Our ref: 22/17047
Your ref: 16034

DA T6-14-67: Proposed Quarry at Crescent Head Road, Kempsey
Additional Information

Client
Project **TRAFFIC ASSESSMENT FOR CHURCH HILL QUARRY**
Title **PLAN AND LONG SECTION SHEET 1**

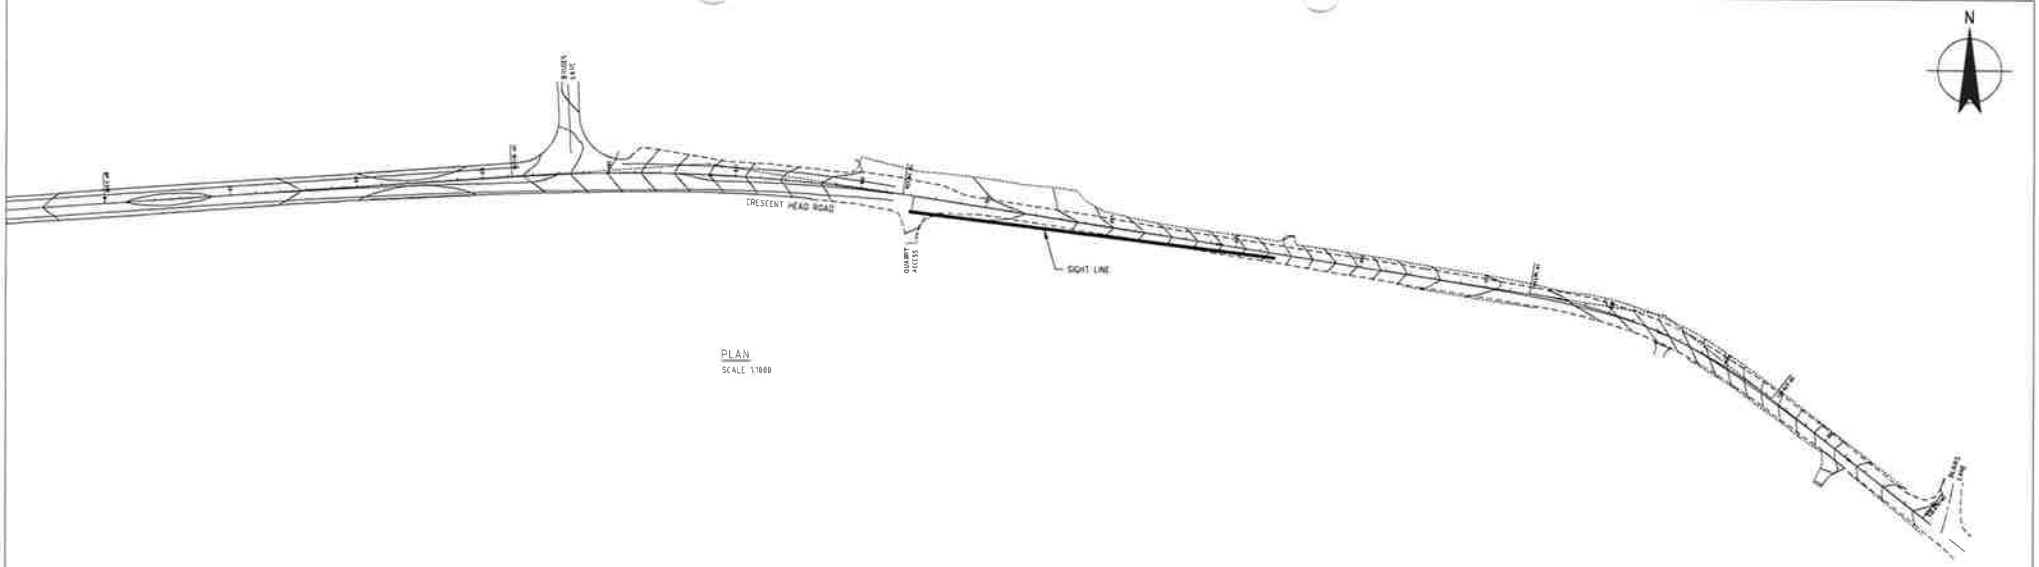
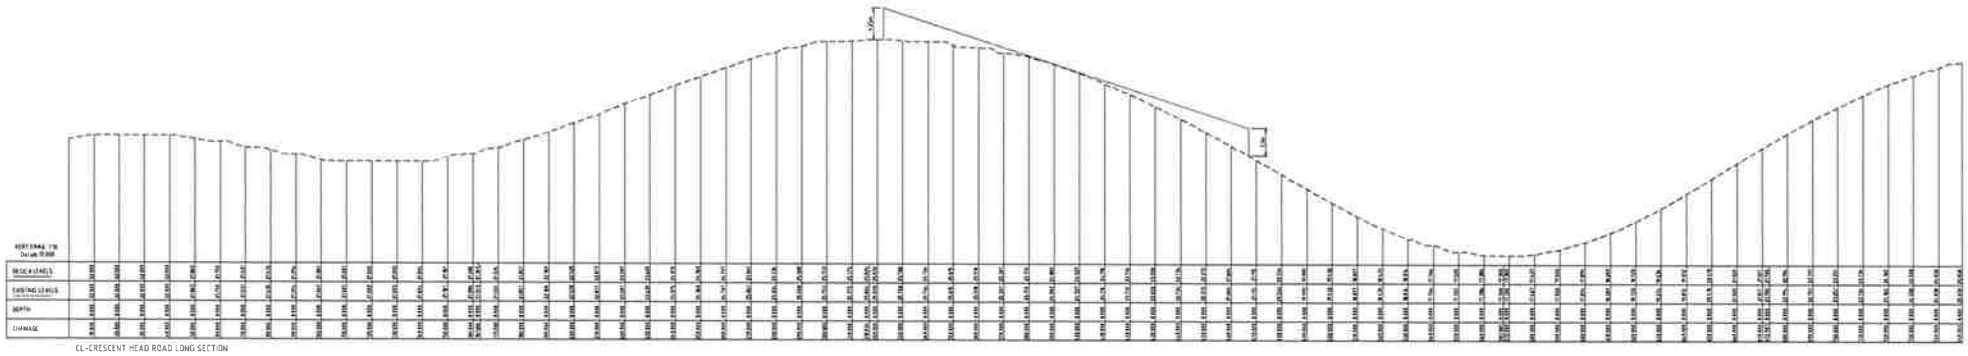
(e) A topographical survey was undertaken to provide the basis for measuring the available sight distance between a car stopped 5 metres from the yield line at the access road and a car approaching from the east. The limiting features are the crest vertical curve and the tree on the verge. The available sight distance is 146 metres. As reported, the SISD as shown in Table 3.2 of Austroads GTRD Part 4A

is 151 metres. Allowing for a reduction of 5 metres due to the approximately 4% upgrade for eastbound traffic, the required SISD is 146 metres. That is, the available sight distance is equal to the required sight distance. The plan and longitudinal section showing the sight line are attached.
